Independent Review of Flood Modelling Undertaken for the Macintyre River Floodplain

Inland Rail Project - Border to Gowrie (B2G)

Goondiwindi Regional Council
1283-02-E, 29 April 2021

Figure 7-9 - Updated flood impacts for the 1% AEP design event

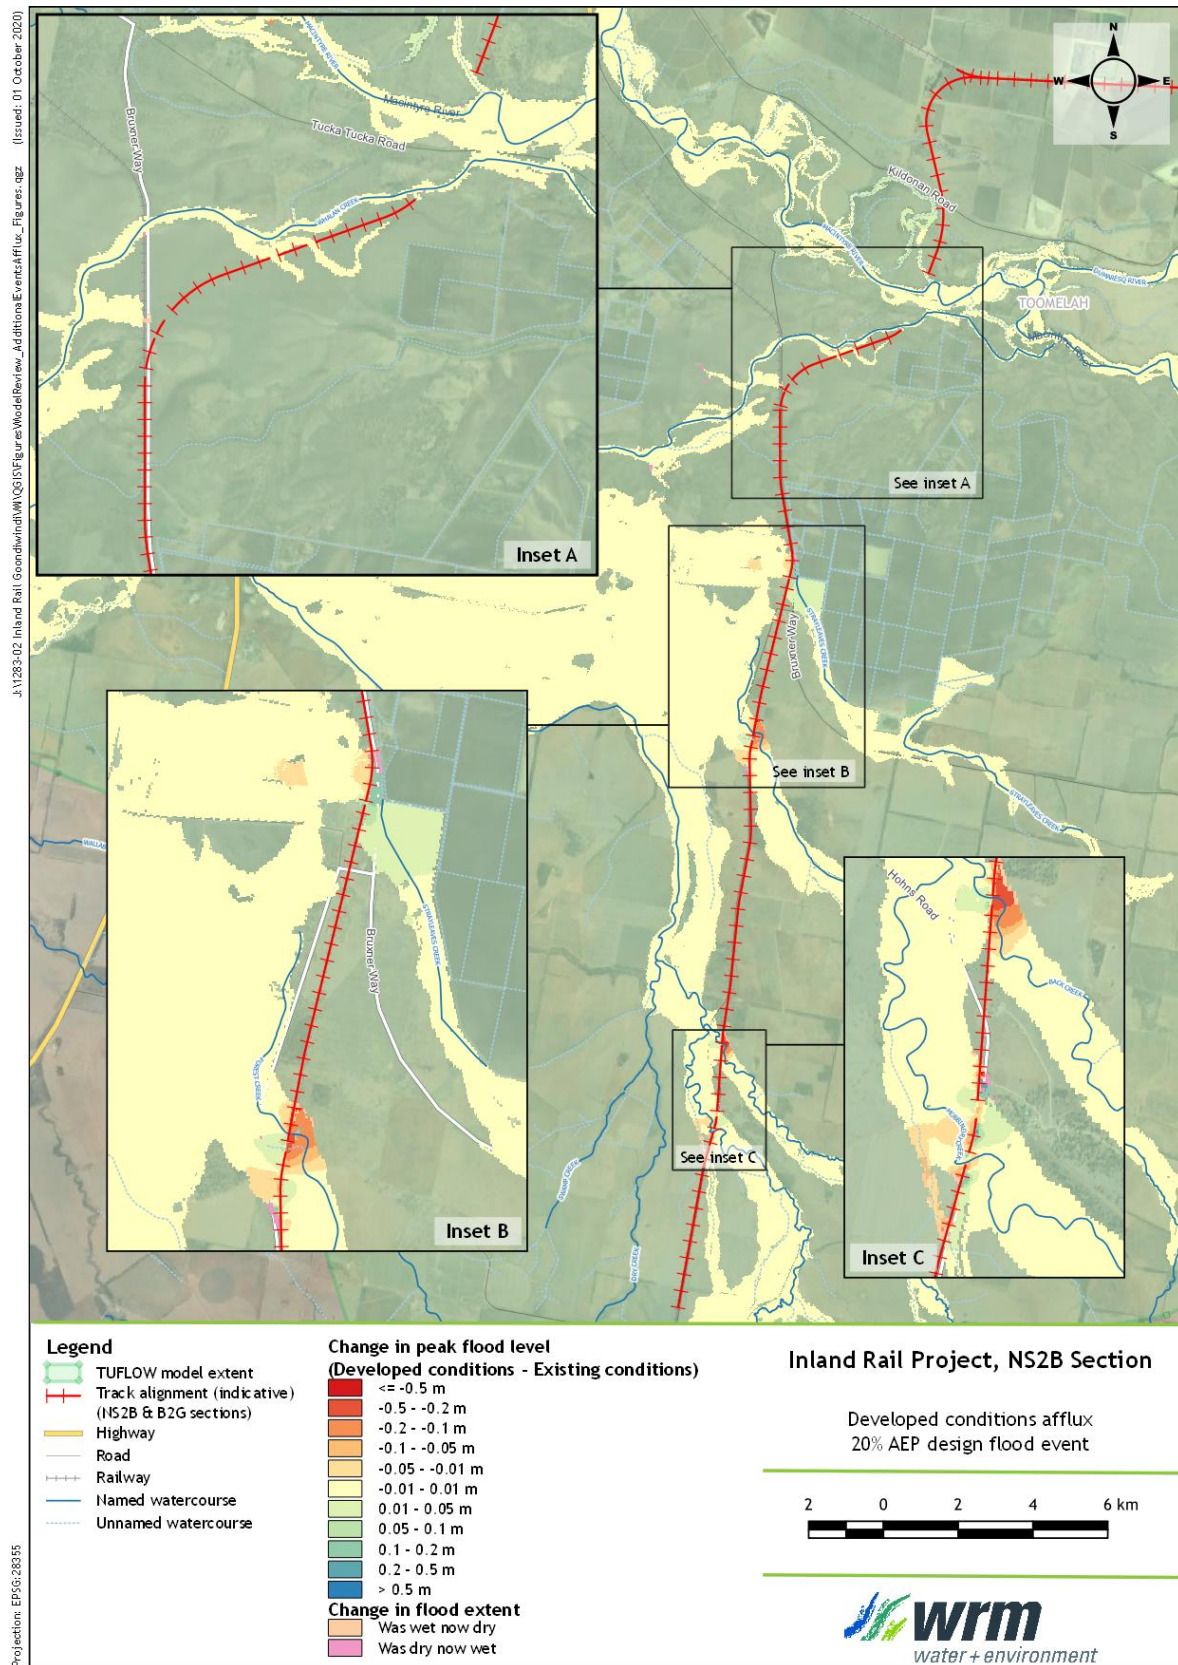
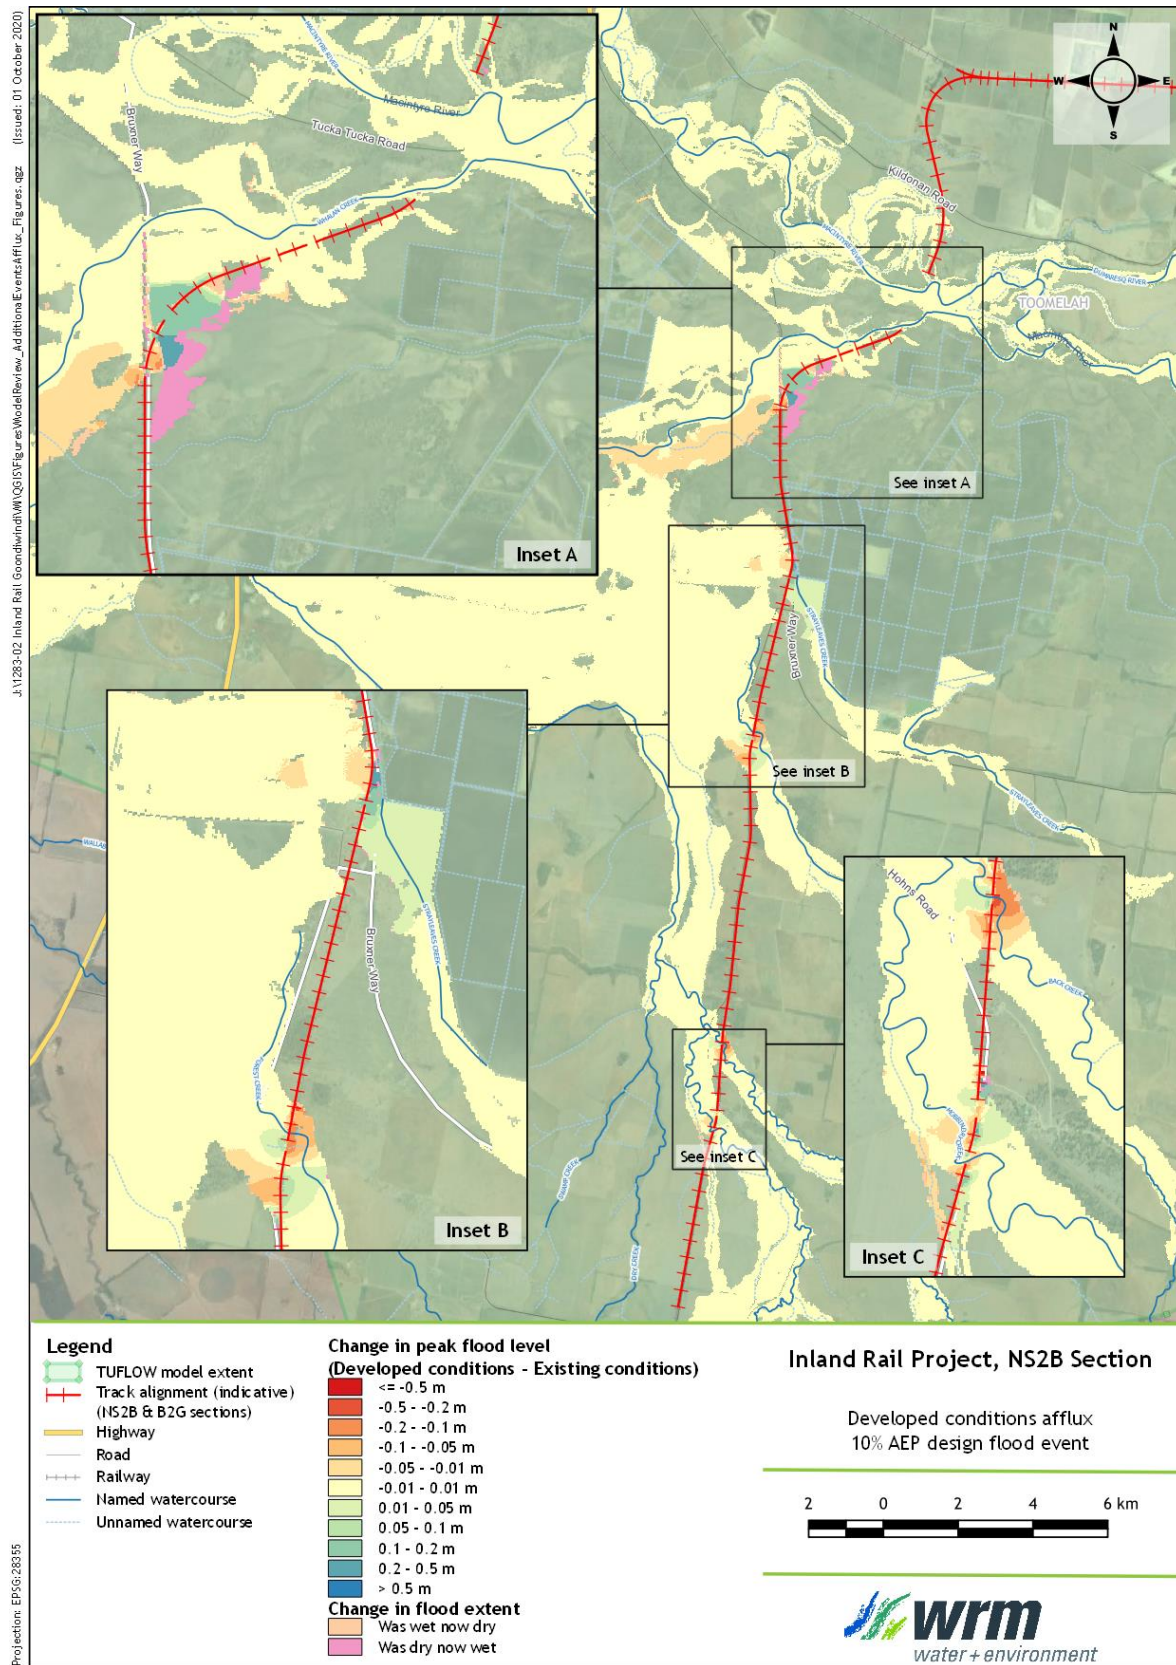
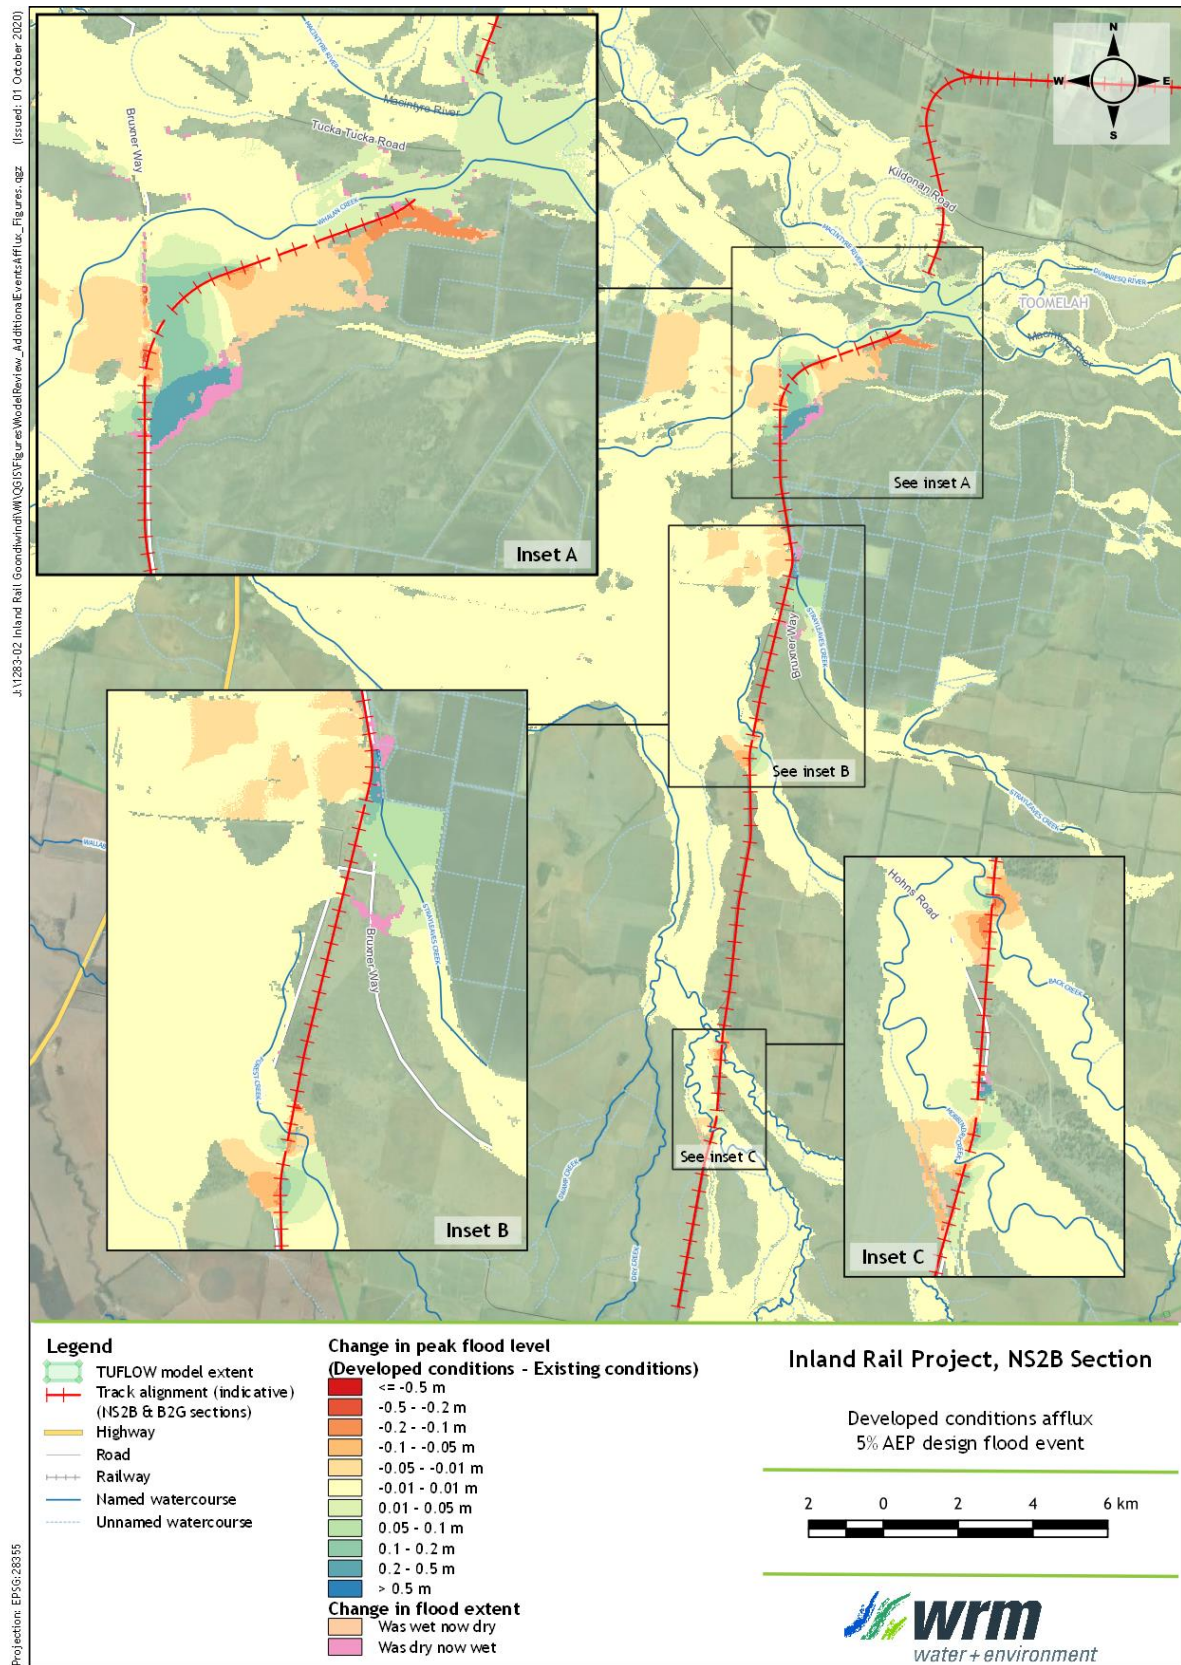
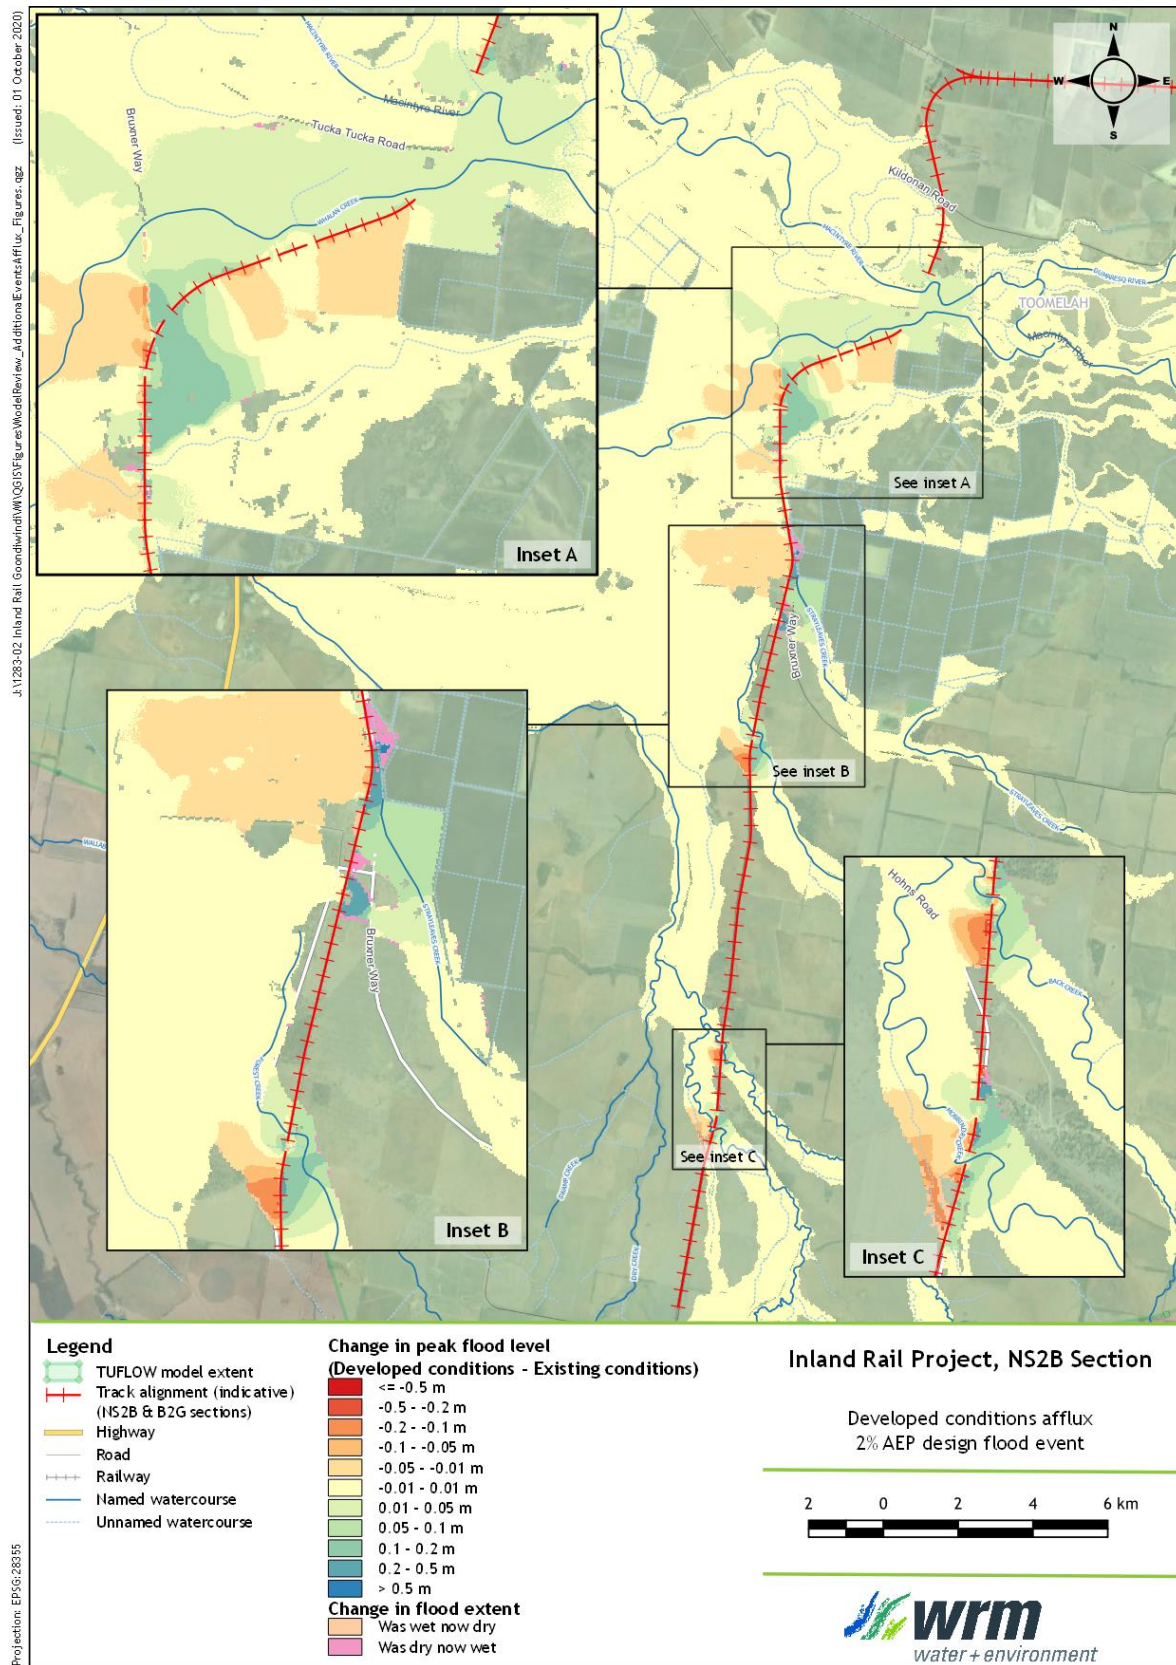
Figure 7-5 to Figure 7-9 show the updated flood impact maps for 20% AEP to 1% AEP design flood events along the NS2B alignment, including the locations where the impacts exceed the flood impact objective limits. These flood maps also show that:

- At the Mobbindry Creek crossing, there are upstream impacts that are greater than the established flood impact objective limits upstream of the rail line for all flood events shown.

- For the mapped events, the flood impacts generally increase with flood magnitude.
 - There are some localised areas with impacts greater than 0.5 m for the larger flood events.
